Department of Planning and Environment

**Sydney Metro City & Southwest – Chatswood to Sydenham (SSI 7400)
Sydney Metro Trains Facility South and Marrickville Dive Station Design and Precinct Plan**

Station Design and Precinct Plan – Sydney Metro Trains Facility South and Marrickville Dive

Project:	Chatswood to Sydenham	Date:	4 April 2022
Group:	C&SW SEP	Status:	Final
Author:	Julieanne Boustead	Revision:	L
Company:	Sydney Metro	File number:	SMCSWLWC-SYC-DSY-EM-PLN-005684
File name:	Station Design and Precinct Plan (SDPP) – SMTF South and Marrickville Dive

Figure 4-9 SMTFS and Marrickville Dive Sites – Sydenham Station Precinct – Current Planning Framework. Source: Draft Sydenham to Bankstown Urban Renewal Corridor Strategy 2017

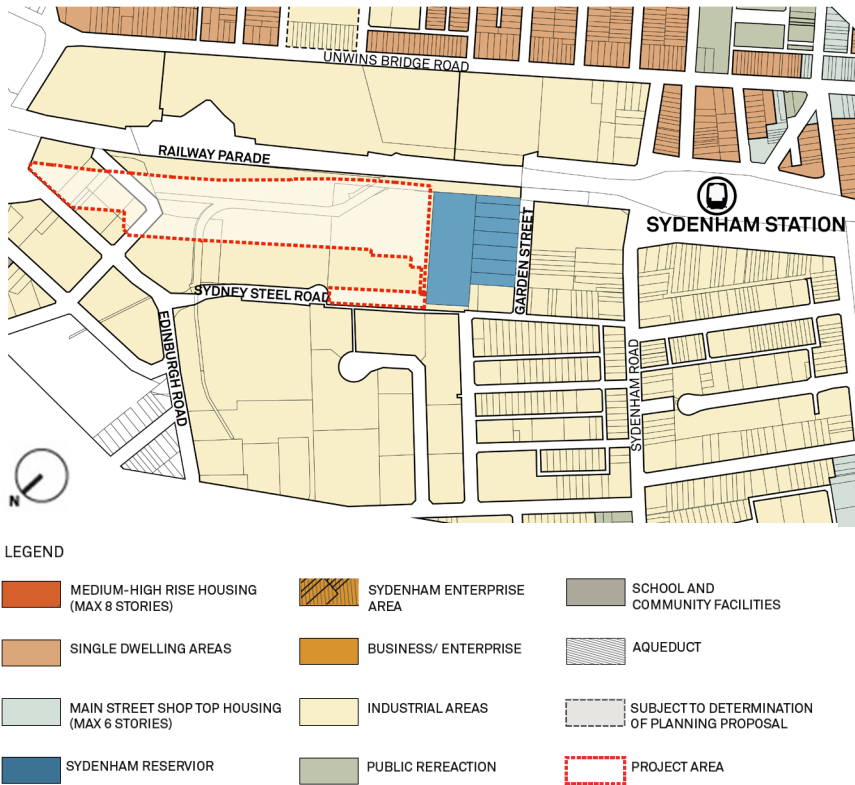
Topic	Council comments	Community/Stakeholder comments	How feedback has been addressed
Planning Framework	Figure 4-9 is incorrect, as the <i>Draft Sydenham to Bankstown Urban Renewal Corridor Strategy 2017</i> was abandoned by the state government, and the planning responsibility returned to Council.		Diagram and wording has been amended to reflect the comments and reference to 'Revised' removed
Planning Framework	It should be noted that the nearby Woolworth's development mentioned in the SDPP has not been built, nor is it currently the subject of a Planning Proposal or Development Application		Figures and narrative have been amended to reflect the correct footprint of the "Neighbouring development proposals location plan". Feedback is appreciated.
Planning Framework	The Sydenham to Bankstown Strategy discussed in the SDPP was only ever a draft and has since been abandoned by the State Government.		Diagram and wording has been amended to reflect the comments and reference to 'Strategy' removed
